Access Compliance Report Public Rights-of-Way (Pedestrian Signals)

Main Street: ROSE_DR Cross Street: VALENCIA_AVE Location: SE

ADA ID: SGAT210920142337 Signal Type: One Push Button-APS Overall Compliance: No Severity Scores: BTN 1: 25 BTN 2: N/A No BTN: N/A

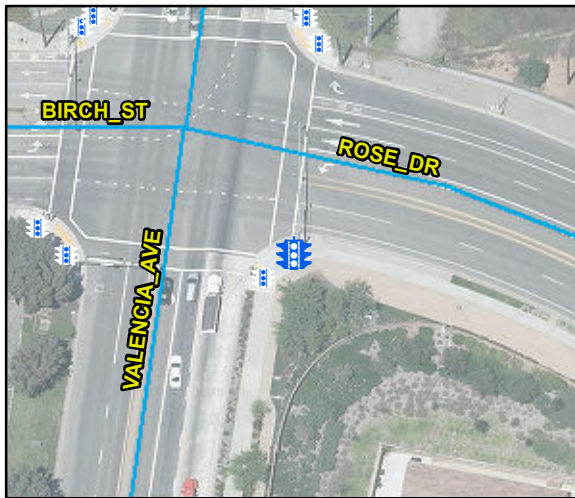
Compliance	Description	Data	Compliance	Description	Data
Button Count		Button1	Yes	Distant to Additional Button (in)	200
Additional Button Present?		Yes	N/A	Additional Button ID	SGAT210920142114
Located In An Island/Median?		No			
N/A B 1 Sign Present?		Yes	N/A	B 2 Sign Present?	N/A
Yes B 1 Sign Purpose?		Yes	N/A	B 2 Sign Purpose?	N/A
Yes B 1 Sign Lettering & Contrast?		Yes	N/A	B 2 Sign Lettering & Contrast?	N/A
Yes B 1 Parallel To XWalk?		Yes	N/A	B 2 Parallel To XWalk?	N/A
N/A B 1 PAR to Button?		N/A	N/A	B 2 PAR to Button?	N/A
N/A B 1 PAR to XWalk?		N/A	N/A	B 2 PAR to XWalk?	N/A
Yes B 1 Clear Floor Space?		Yes	N/A	B 2 Clear Floor Space?	N/A
N/A B 1 FWD Approach?		N/A	N/A	B 2 FWD Approach?	N/A
N/A B 1 FWD Approach Constrained?		N/A	N/A	B 2 FWD Approach Constrained?	N/A
N/A B 1 FWD Approach Reach (in)		N/A	N/A	B 2 FWD Approach Reach (in)	N/A
N/A B 1 FWD Approach Width (in)		N/A	N/A	B 2 FWD Approach Width (in)	N/A

N/A B 1 FWD Approach Obstruction?		N/A	N/A	B 2 FWD Approach Obstruction?	N/A
N/A B 1 FWD Approach Obstruction Dist (in)		N/A	N/A	B 2 FWD Approach ObstructionDist (in)	N/A
N/A B 1 PARA Approach?		N/A	N/A	B 2 PARA Approach?	N/A
N/A B 1 PARA Approach Constrained?		No	N/A	B 2 PARA Approach Constrained?	N/A
Yes B 1 PARA Approach Reach (in)		0	N/A	B 2 PARA Approach Reach (in)	N/A
N/A B 1 PARA Approach Width (in)		N/A	N/A	B 2 PARA Approach Width (in)	N/A
N/A B 1 PARA Approach Obstruction?		No	N/A	B 2 PARA Approach Obstruction?	N/A
N/A B 1 PARA Approach Obstruction Dist (in)		N/A	N/A	B 2 PARA Approach Obstruction Dist (in)	N/A
Yes B 1 Clear Floor Space Slope (%)		1.3	N/A	B 2 Clear Floor Space Slope (%)	N/A
No B 1 Clear Floor Space XSlope (%)		2.4	N/A	B 2 Clear Floor Space XSlope (%)	N/A
N/A B 1 PAR Slope (%)		0.6	N/A	B 2 PAR Slope (%)	N/A
Yes B 1 Height (in)		42	N/A	B 2 Height (in)	N/A
Yes B 1 Pressure (#)		5	N/A	B 2 Pressure (#)	N/A

Yes B 1 Closed Fist Operation?		Yes	N/A	B 2 Closed Fist Operation?	N/A
Yes B 1 Diameter (in)		2.25	N/A	B 2 Diameter (in)	N/A
N/A B 1 Crossing Direction		N	N/A	B 2 Crossing Direction	N/A
No B 1 DistanceTo XWalk (in)		72	N/A	B 2 DistanceTo XWalk (in)	N/A
No B 1 DistanceTo Curb (in)		136	N/A	B 2 DistanceTo Curb (in)	N/A
Parcel Identification Number		320-401-09			
Google Street View Link					
http://www.google.com/maps/@?api=1&map_action=pano&viewpoint=33.91826106,-117.84765997

Possible Solutions: Replace Signal Push Button With APS Button. Remove & Relocate Sign.

OC Std/PROW: MUTCD 4e.08, R404.2
